**Economic Commission for Europe**
**Inland Transport Committee**
**World Forum for Harmonization of Vehicle Regulations**
**Working Party on General Safety Provisions**
**110<sup>th</sup> session**

**Report of the Working Party on General Safety Provisions  
 on its 110<sup>th</sup> session (26 – 29 April 2016)**
**Contents**

Figure 1

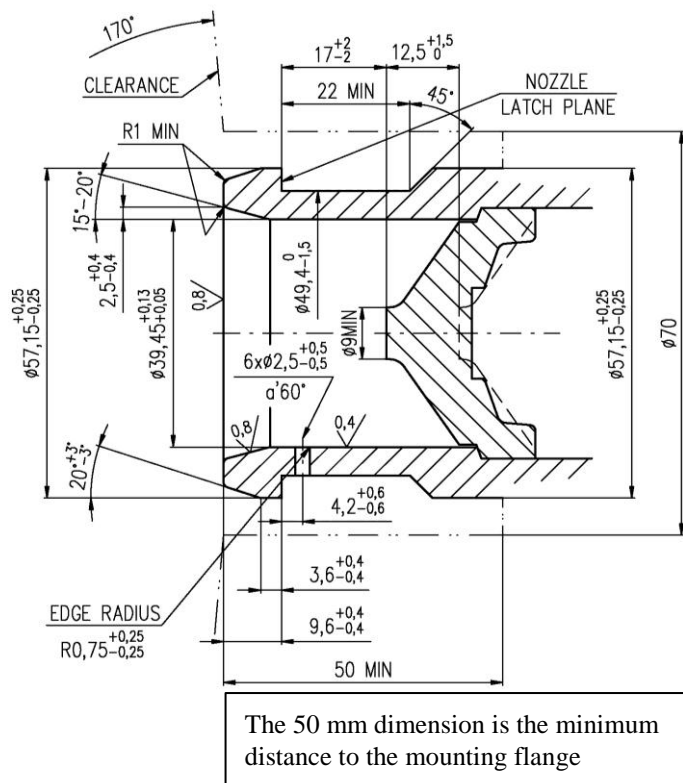
37. The expert from the Netherlands presented ECE/TRANS/WP.29/GRSG/2016/9 aimed at correcting a typographical error and clarifying the current provisions of the Regulation. He also introduced ECE/TRANS/WP.29/GRSG/2016/10 proposing to insert provisions for LNG fuel connector as specified in ISO 12617:2015. Both documents received a number of comments. The expert from France raised a study reservation on the reference to the ISO standard in paragraph 2.2. of Annex 4J. Following the discussion, GRSG adopted both proposal as reproduced below and requested the secretariat to submit it to WP.29 and AC.1 for consideration at their November 2016 sessions, as part (see paras. 32 and 36 above) of draft Supplement 5 to the 01 series of amendments to UN Regulation No. 110:

*Insert new paragraphs 4. and 4.1.*, to read:

**4. LNG filling receptacle dimensions**

**4.1. Figure 1 shows the dimensions of the LNG filling receptacle.**

**Figure 12B**

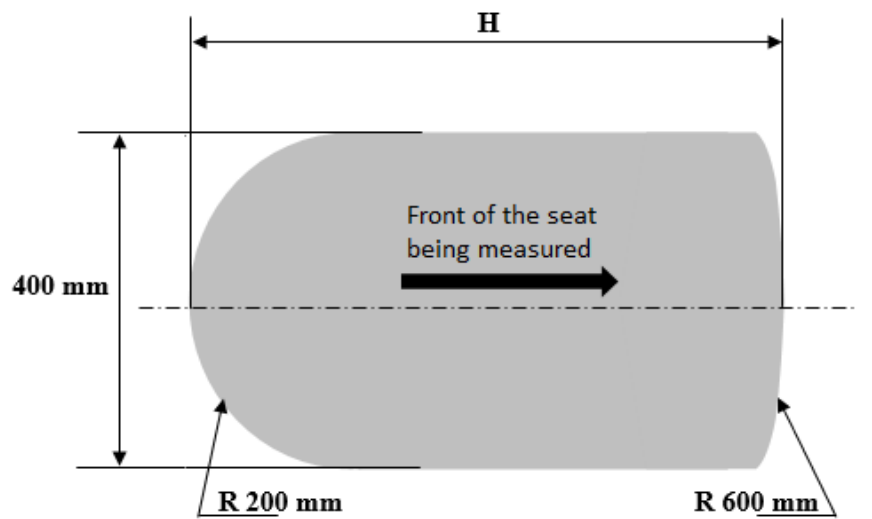
*Annex 4, Figure 12, amend to read:*

**Testing gauge for H dimension (see Annex 3, paragraph 7.7.8.4.2.)**

7.7.8.4.2. All measurements shall be taken, with the seat cushion and squab uncompressed **using the testing gauge shown in Annex 4, Figure 12B."**

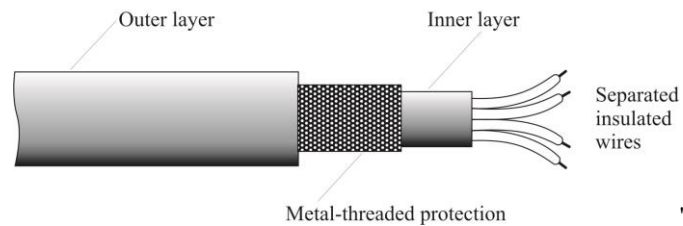
**The additional protection is complied with if multicore cables in conformity with ISO 14572:2011 are used or one of the examples in Figures 1 to 4 below or another configuration that offers equally effective protection is used.**

**Cables located to the rear of the driver's cab and on trailers shall be additionally protected to minimize any unintended ignition or short-circuit in the event of an impact or deformation.**
